Addendum #2

Project: 2024 – Fishers Elementary School Addition & Renovations

ADDENDUM NO: 2

PROJECT: 2024 – Fishers Elementary School Addition and Renovations

A600

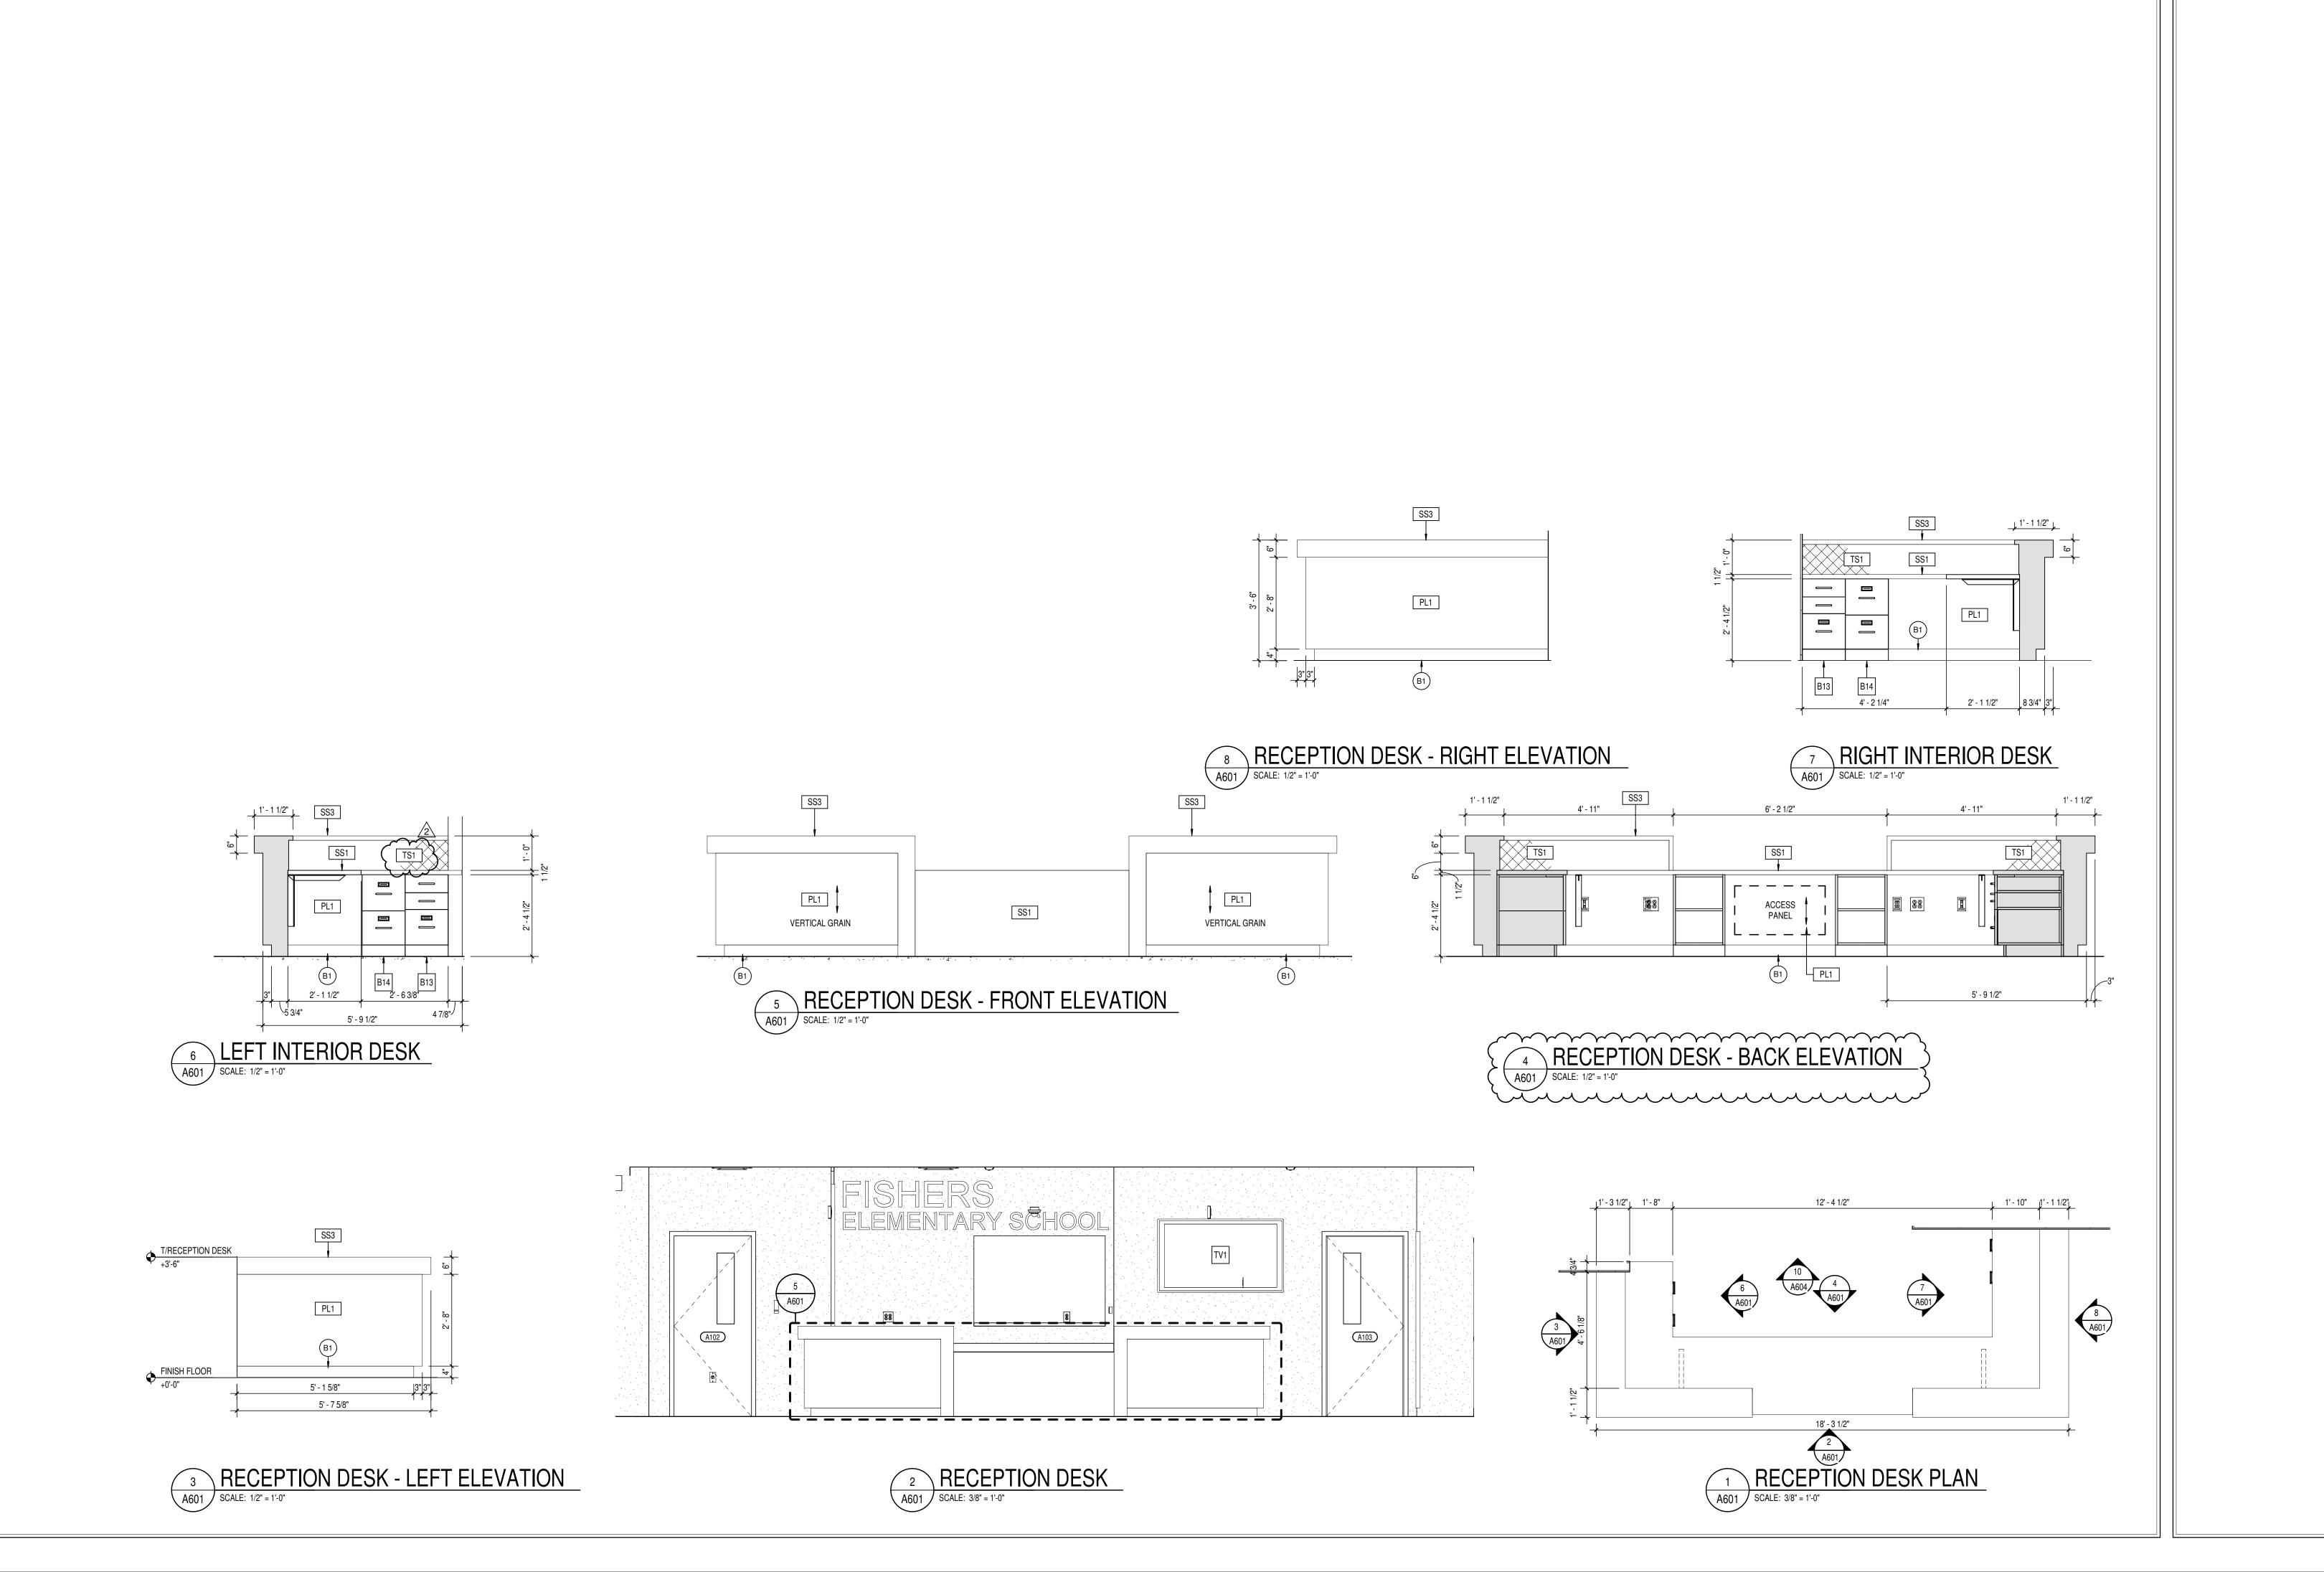
- 4.11 <u>A600 CASEWORK SCHEDULE</u>
  - A. Revised section on sheet
  - B. Added general casework notes
- 4.12 <u>A601 CASEWORK ELEVATIONS AND MILLWORK DETAILS</u>

A601

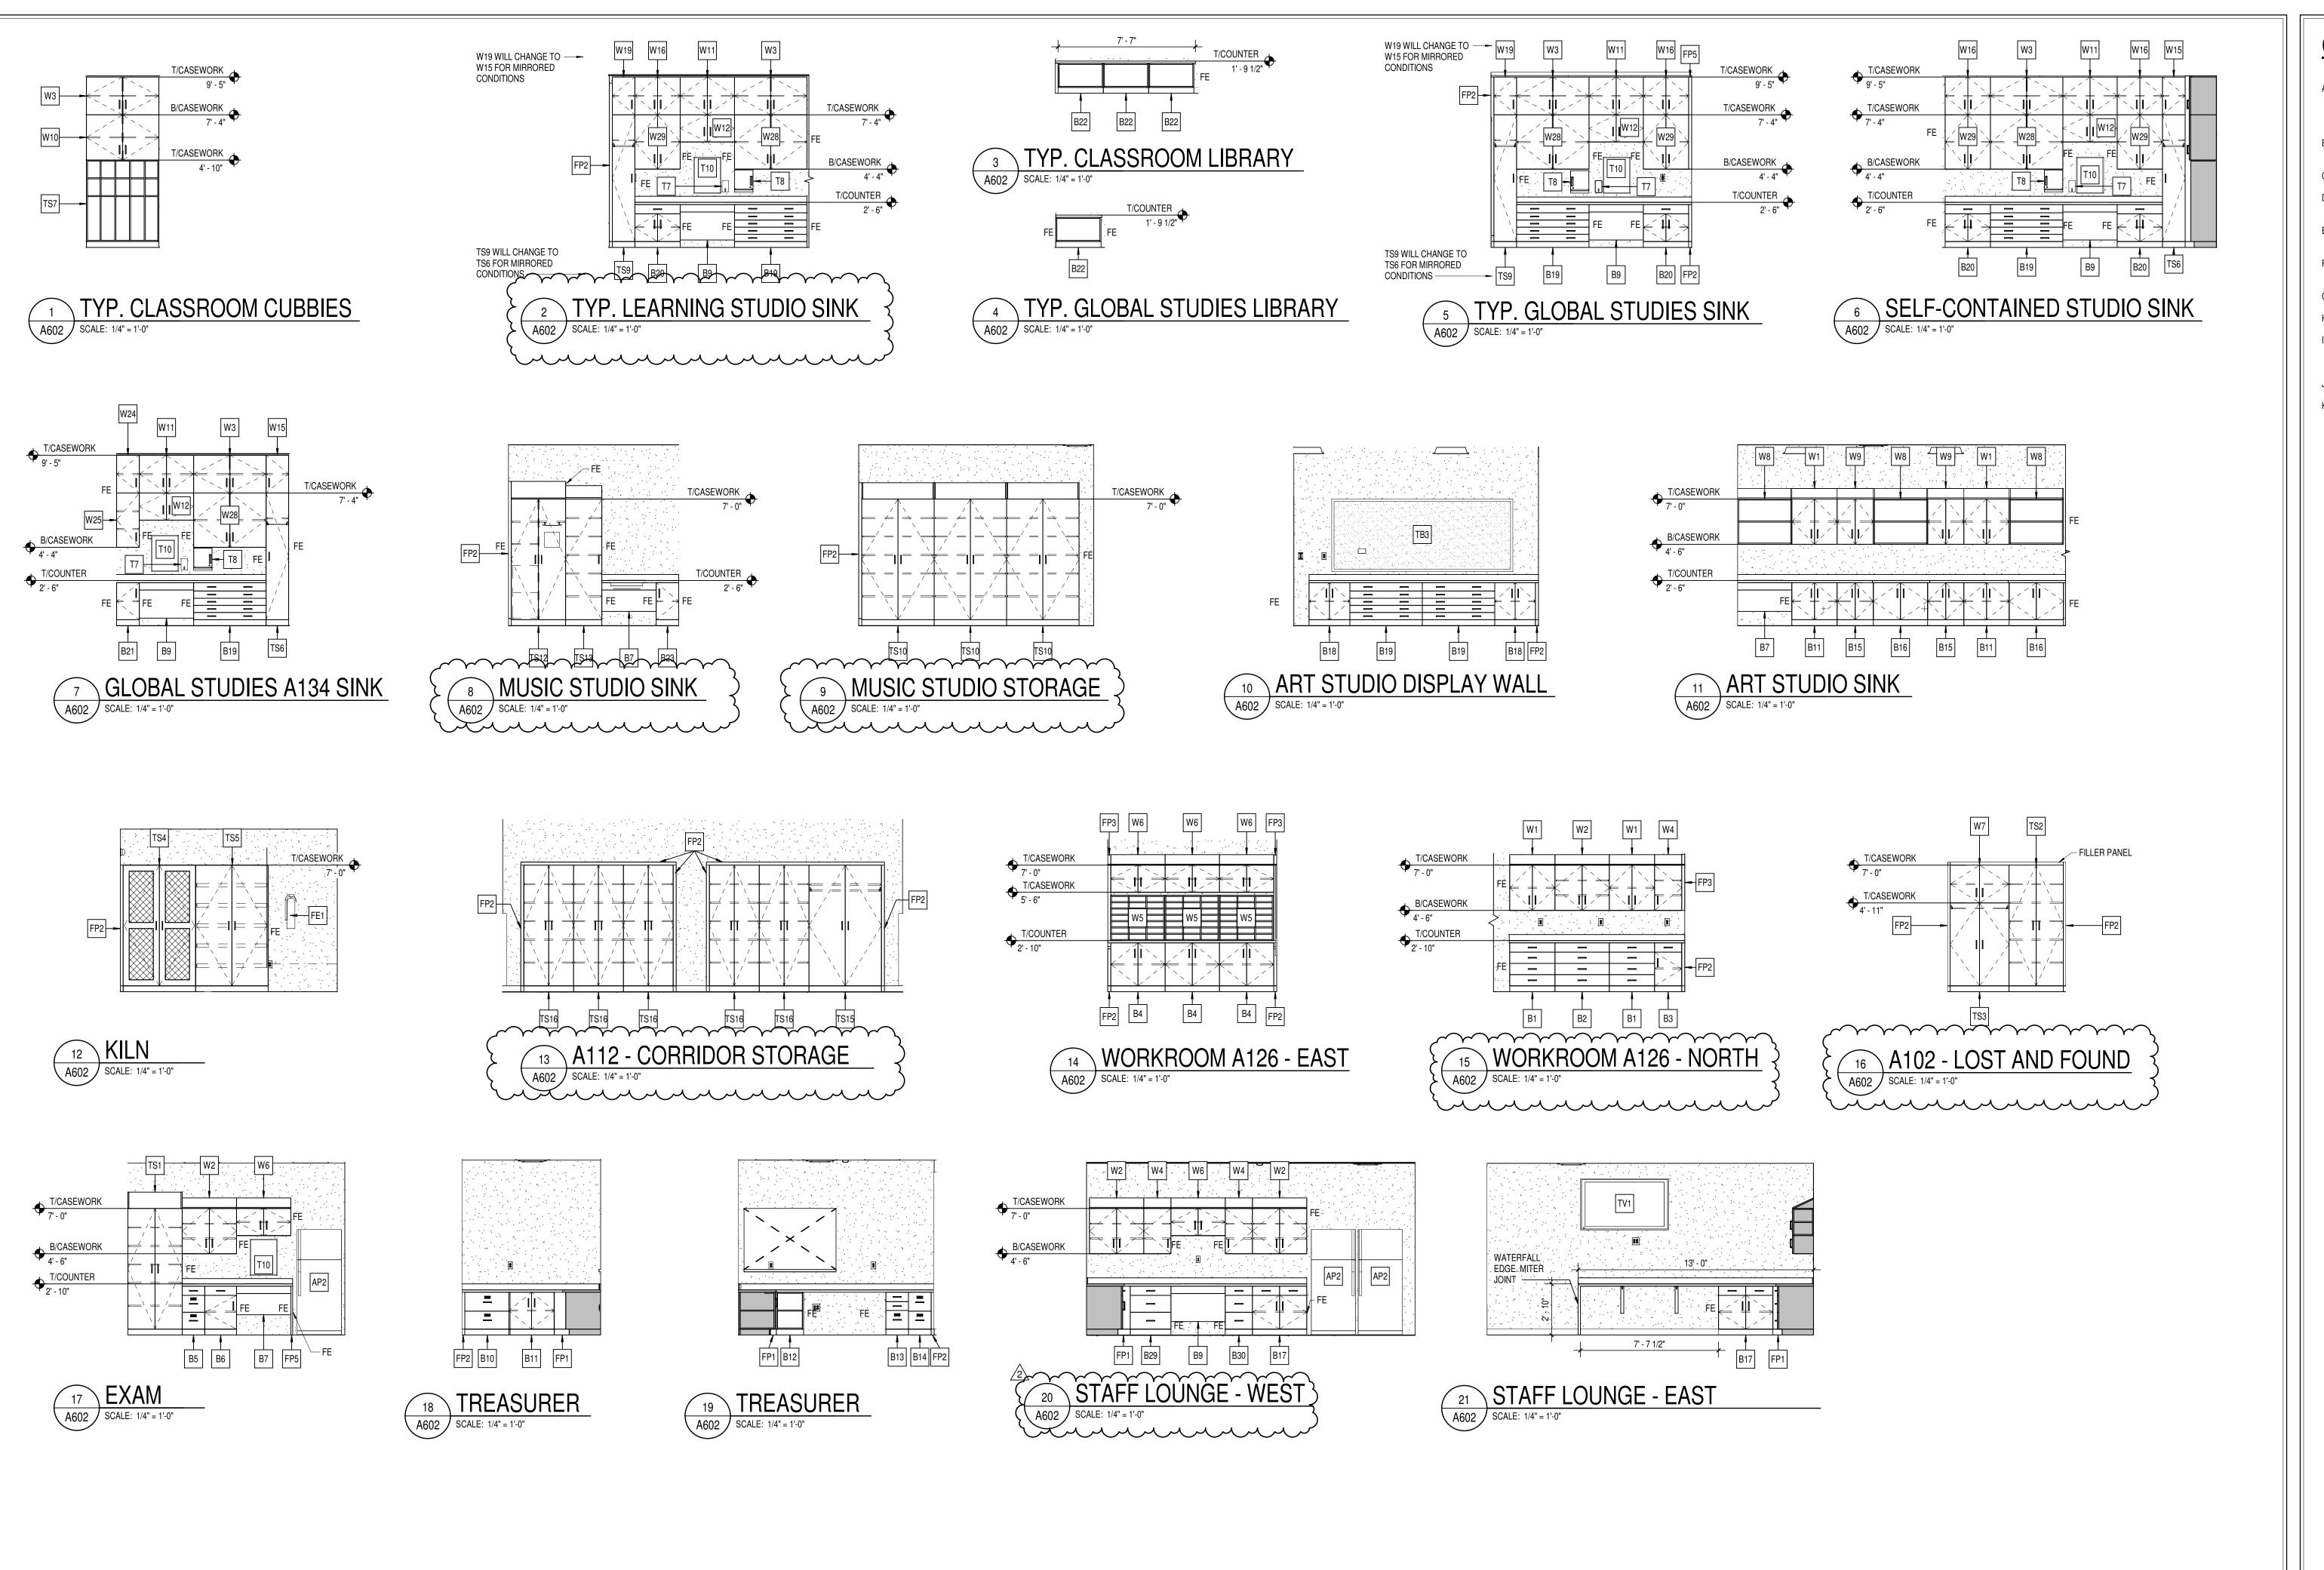
- A. Revised elevation on sheet
  - B. Revised PL1 to TS1 on 6/A601
- 4.13 <u>A602 CASEWORK ELEVATIONS</u>
  - A. Added casework tags
  - B. A604 INTERIOR ELEVATIONS

A604

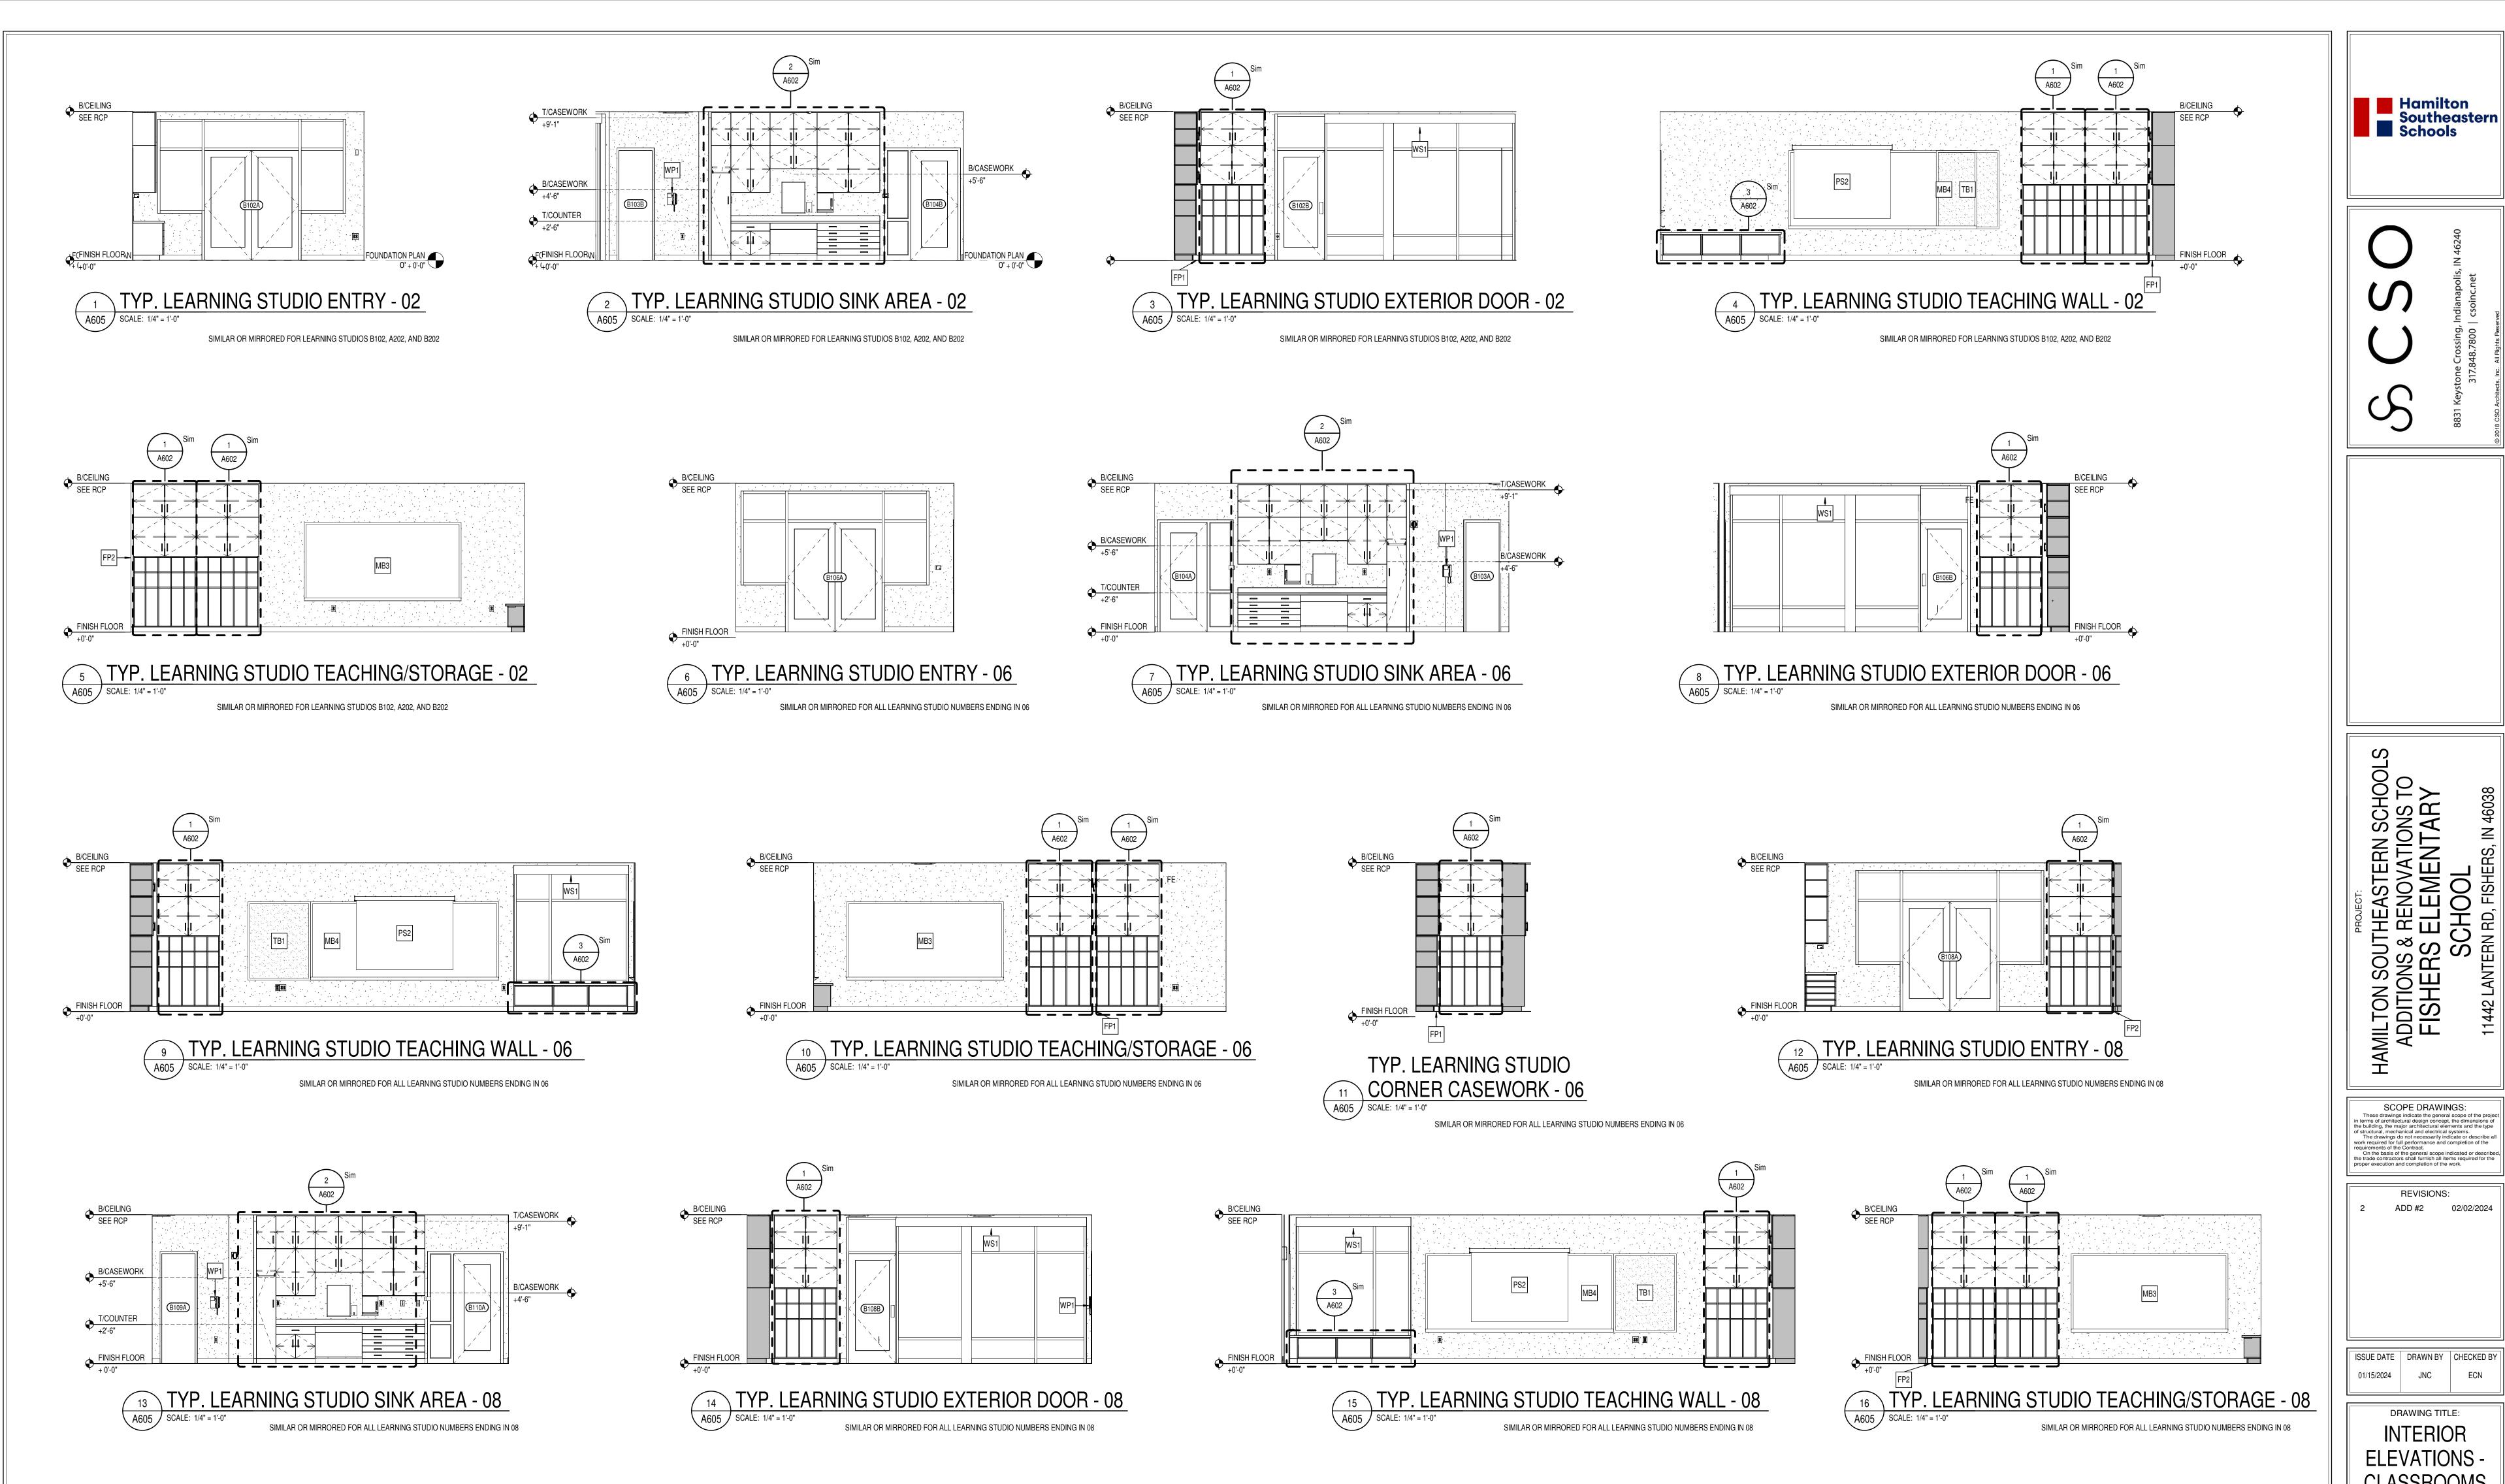
- C. Added dimensions to 7/A604 and 8/A604
- D. Revised 10/A604 to include TV tag and opening
- 4.14 A605 INTERIOR ELEVATIONS CLASSROOMS
  - A. Removed FE tags for clarification
